# Product Change Notification

**Change Notification #:** PCN115116-00  
**Change Title:** Intel® Server Chassis R2312WTTYSR, PC115116-00, Product Design, Top screw removal, Change dimension on PCIe\* riser bracket holes, Hot Swap Back Plane Sheet Metal Locator Tab Modification

**Date of Publication:** November 22, 2016

**Image 1.** PCIe\* bracket holes

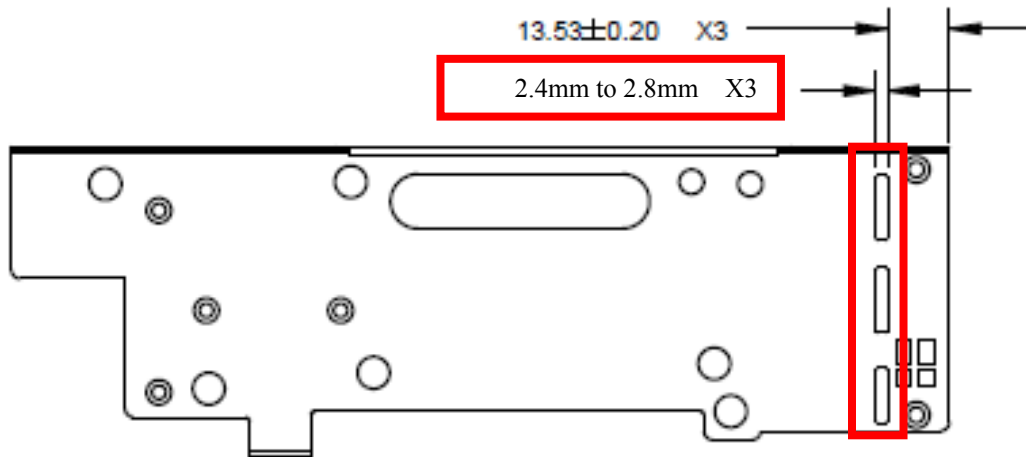
3. The width of the holes in the Peripheral Component Interconnect Express (PCIe) Riser bracket change from 2.4mm to 2.8mm. Please see image below for details:

This change will eliminate any difficulty with customers installing PCIe cards in riser 2 and riser 3 on opposing PCIe slots.

**HSBP Locator tab**

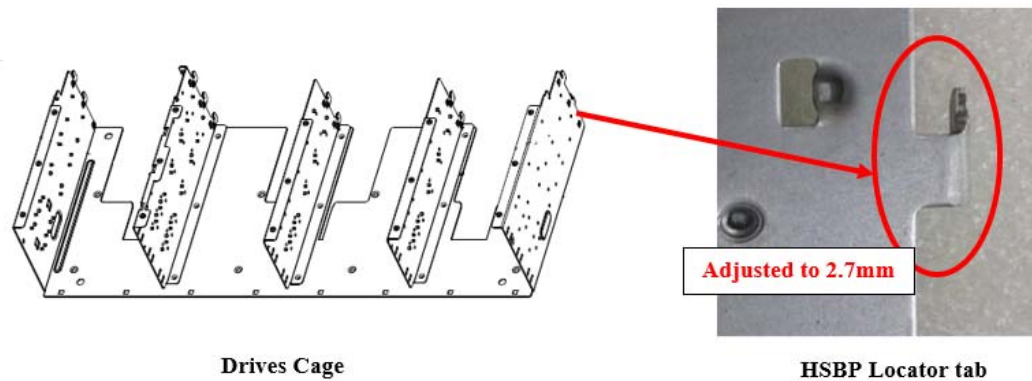
4. The sheet metal of the locator at the bottom tab of the hot swap back plane (HSBP) that is in the right side will be modified to ensure gap of 2.7mm. This modification is needed to provide reliable engagement between the drive and the backplane connectors. Please see additional information in the TA-1107 available at: <http://www.intel.com/content/www/us/en/support/server-products/000022064.html?wapkw=ta-1107>
